DATE: 7-14-05  
PROJECT NO. 2006  
PROJECT: D.B. / TIM LEWIS  
LOCATION: RIVERBEND LOT-79

**RE: Riverbend (Job #24233)  
Inspection Clarification**

LOT 79 3465 RIVER STAGE AVE # 0504779

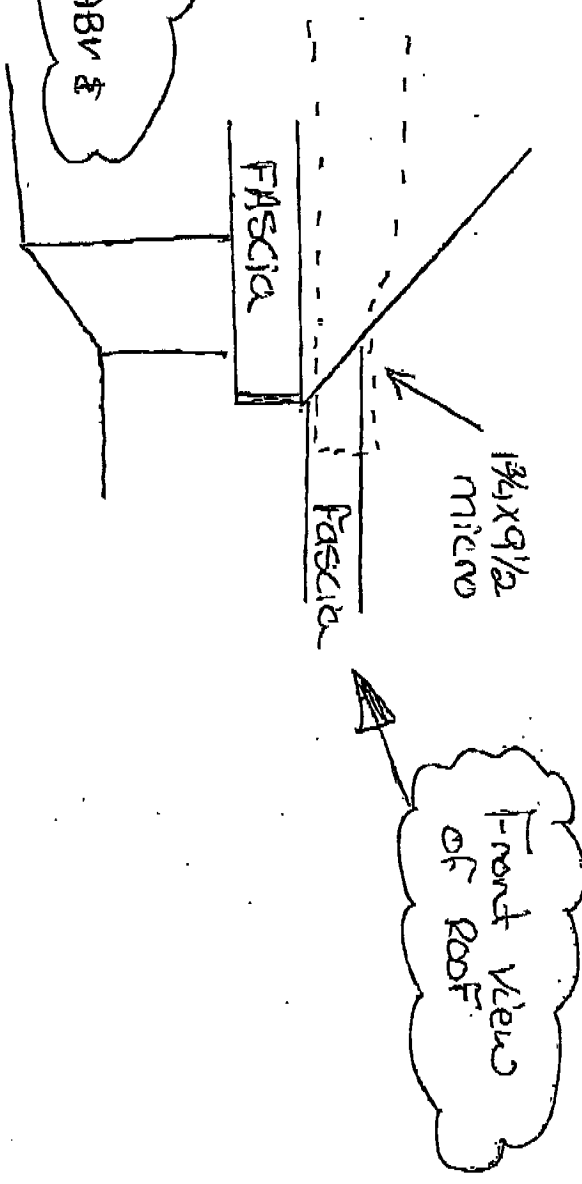
HAD TO START CUT BEAM DUE TO ROOF ABV \$ HIP
